HEARING REPORT

PRIVATE PLAN CHANGE 110

HEIGHTS ROAD, PUKEKOHE

GBAR PROPERTIES LIMITED

Figure 6: Future Urban Land Supply Strategy and Future Development Strategy comparison maps

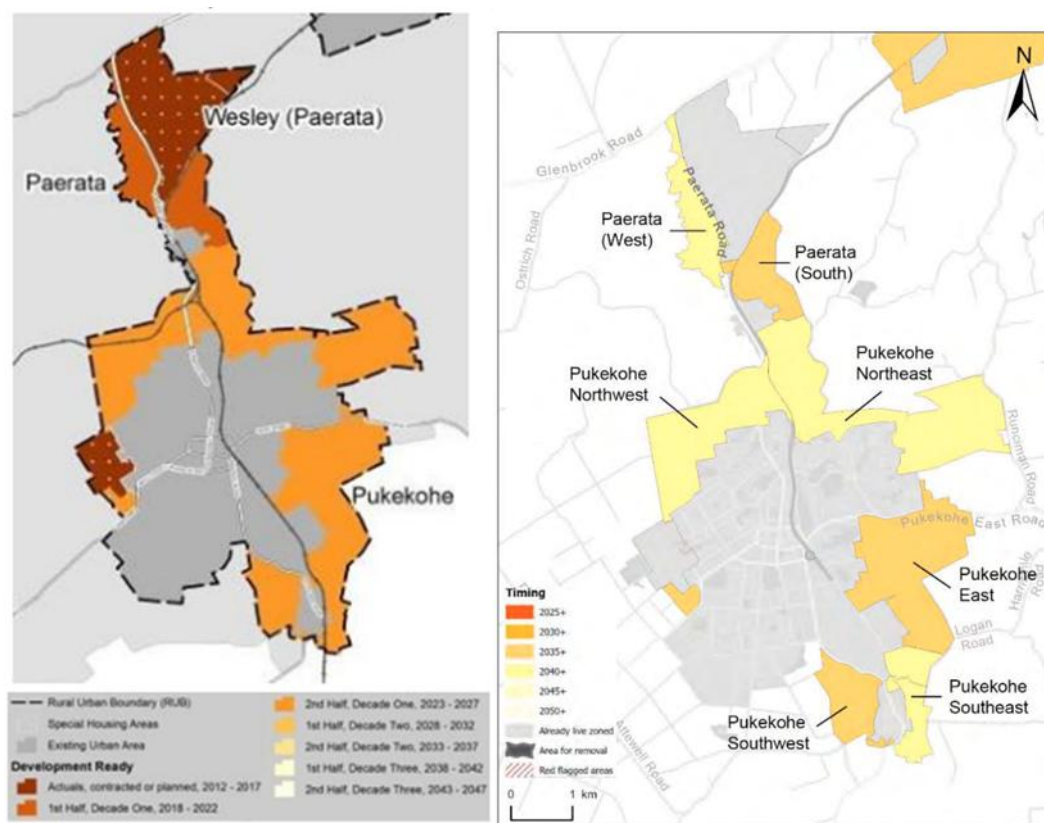
112. There is no intention in the FDS to change the FUZ zoning of the plan change land, however as timing of its development has moved out to 2040+ as shown in Figure 6 below, the proposed plan change proposes development about 16 years ahead of the “development ready” time horizon in the FDS.

113. The FDS leaves open the possibility for the council to consider private sector initiatives which find practical ways to provide infrastructure either through direct provision, or funding council to accelerate its own infrastructure provision where that contributes significantly to housing and business capacity and meets the requirements of a well-functioning urban environment.
114. The FDS lists several “infrastructure prerequisites” for Pukekohe North West, which are addressed later in this report, these being:
- Pukekohe North West Arterial
 - Isabella Drive Pump Station
 - New Reservoir Adams Road South.

Figure 4: Sightlines drawn to match distances provided in TAR

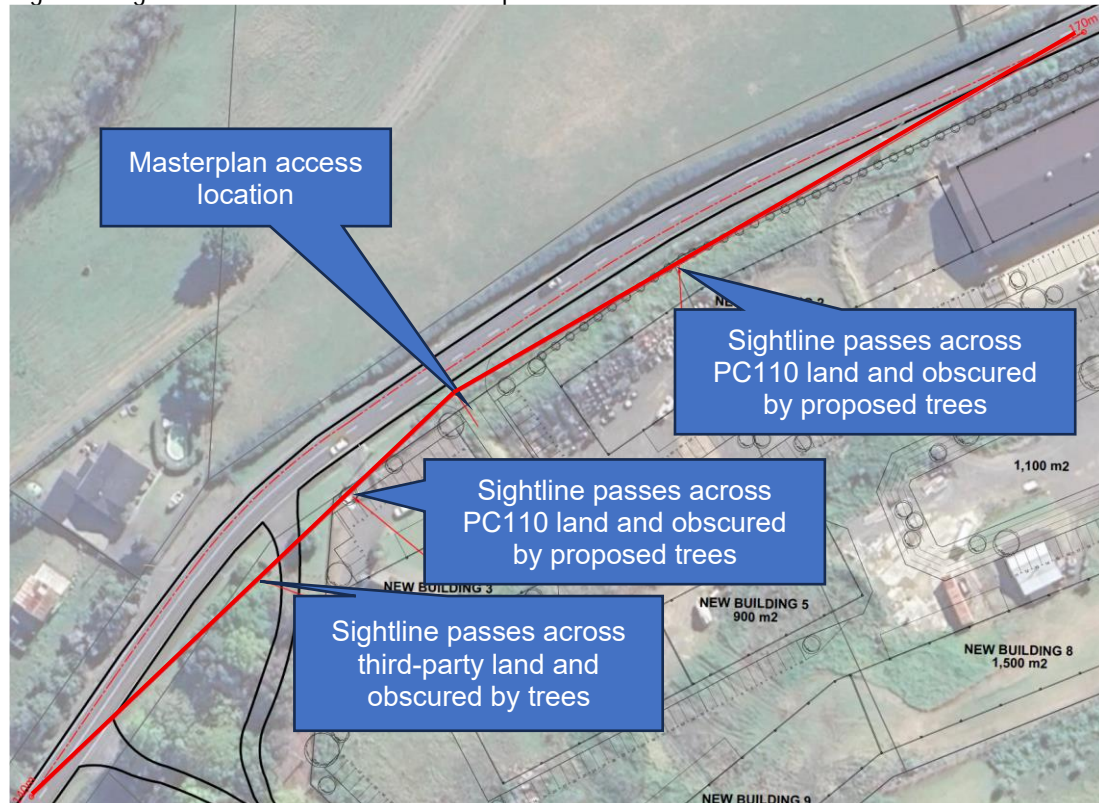
- 3.28 I have plotted the TAR sight distances in a scaled drawing as shown in Figure 4 which demonstrates that both TAR sight lines cross private property and are, or are proposed to be, obscured by trees.

Figure 5: Access location with complying sight distances (154m both directions)

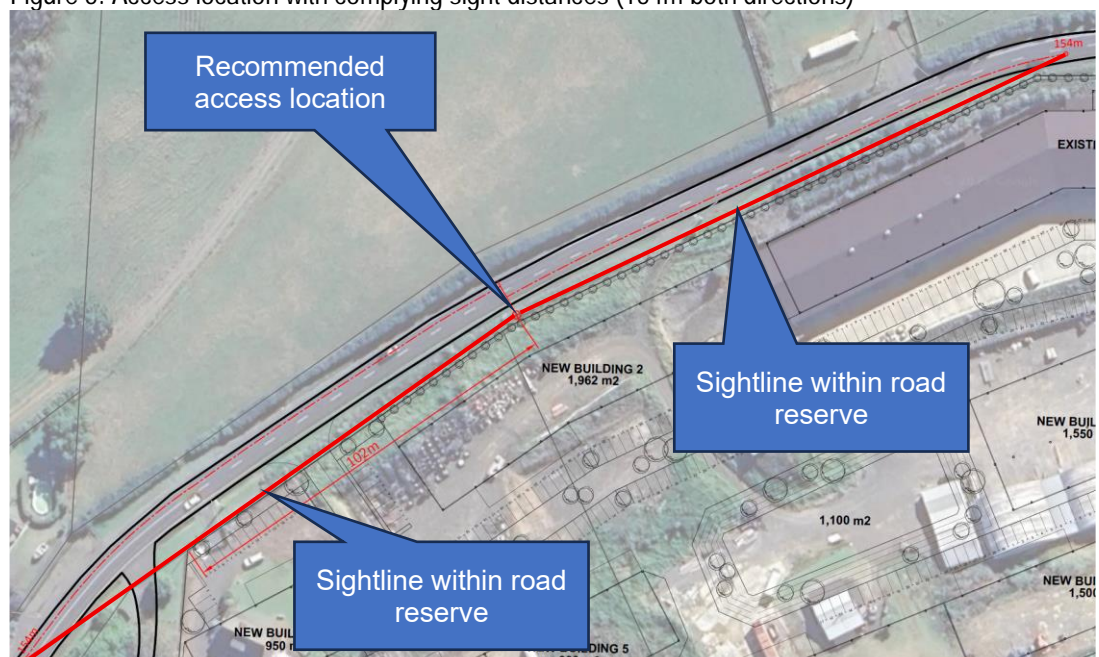
- 3.29 I have identified a location along the site frontage that from my inspection of available imagery should have sight distances sufficient to meet the normal SISD standard. This location is shown in Figure 5 and is 102m east of the western boundary of the Plan Change area.

- 3.30 As the applicant currently controls land fronting the south side of Heights Road it may be possible to provide sufficient sight distances at other locations further east by vesting some land as road. I expect vesting of some plan change land as road would also be necessary to achieve the road upgrading proposed by the applicant in a manner acceptable to AT.

- 3.44 For those reasons I recommend that the access be narrowed to the maximum width of 9m, and if the eastern side of the access were removed it could then be located at least 10m from the NZTA boundary. The land owner could make this change voluntarily, potentially when the road is upgraded to an urban form. Alternatively under E27.4.1(A2) and/or (A5) any use of this vehicle crossing would require consent as a Restricted Discretionary activity unless the crossing were modified to comply.

Figure 6: Crashes reported near plan change area 2020-2024

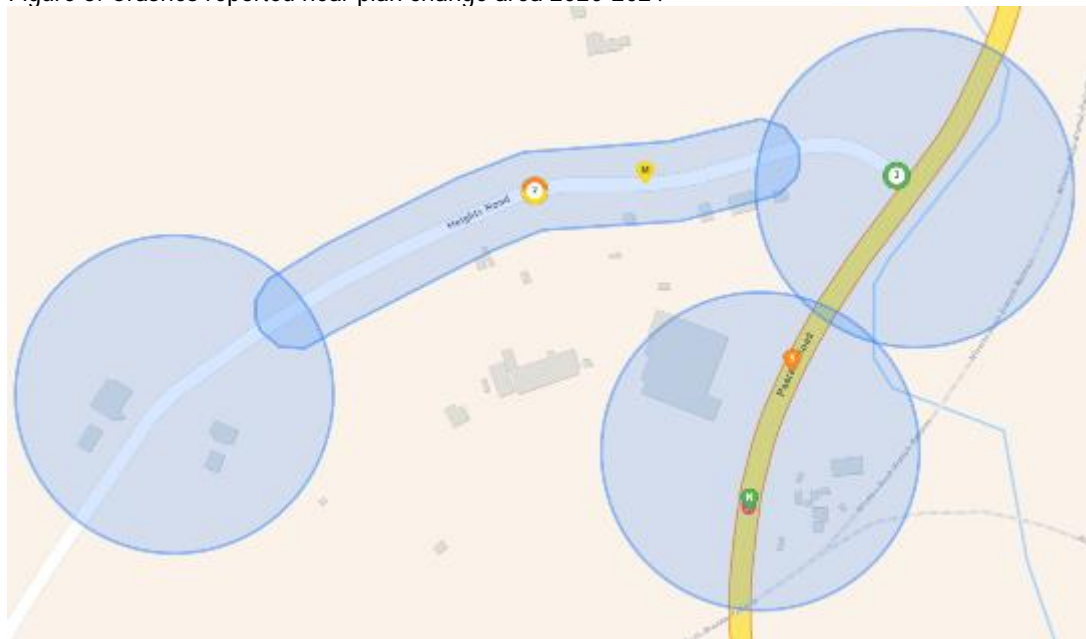
- 3.142 Crash history is typically reviewed for a five-year period to identify hazards. The TAR provides crash data for 2017 to 2021 within 100m of the Plan Change area and for a wider area.
- 3.143 More recent data is now available. The map in Figure 6 shows crashes reported in the 2020-2024 period for the smaller area.

- 3.144 In mid-2020 the speed limit on Heights Road was reduced to 80km/h, and the speed limit on Paerata Road was reduced to 60km/h.

- (a) three non-injury crashes at the intersection for a variety of reasons;
- (b) one serious-injury head-on crash on Heights Road along the Plan Change frontage;
- (c) two minor-injury loss-of-control crashes on Heights Road along the Plan Change frontage;

Figure 7: Crashes reported in wider area 2020-2024

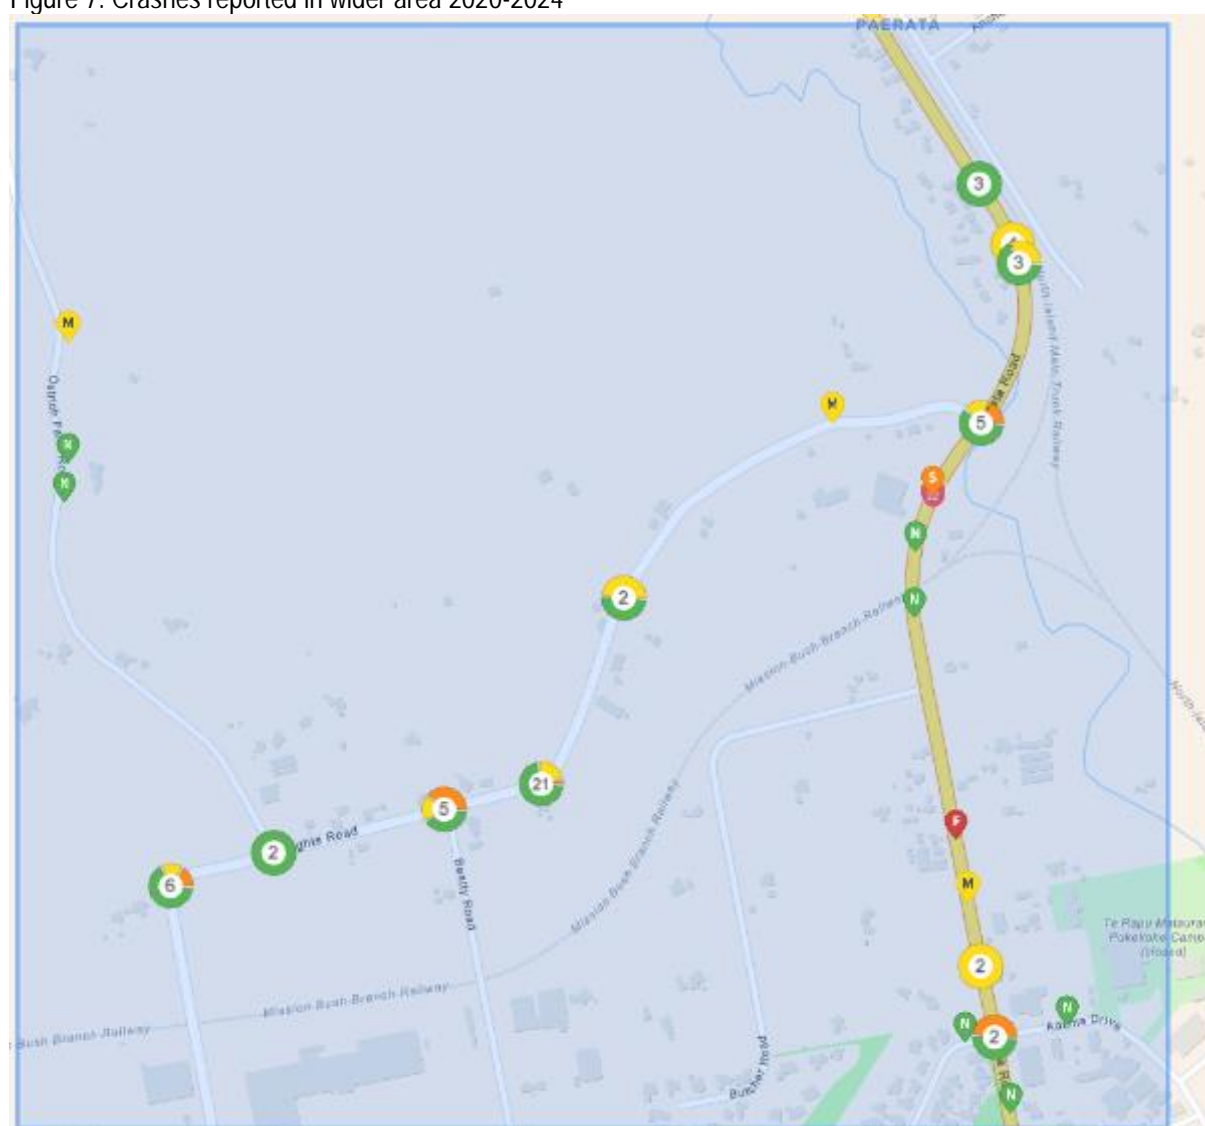
3.146 The 2020-2024 crash history for the wider study area is shown in Figure 7.

3.147 There are several points to note from this wider crash history:
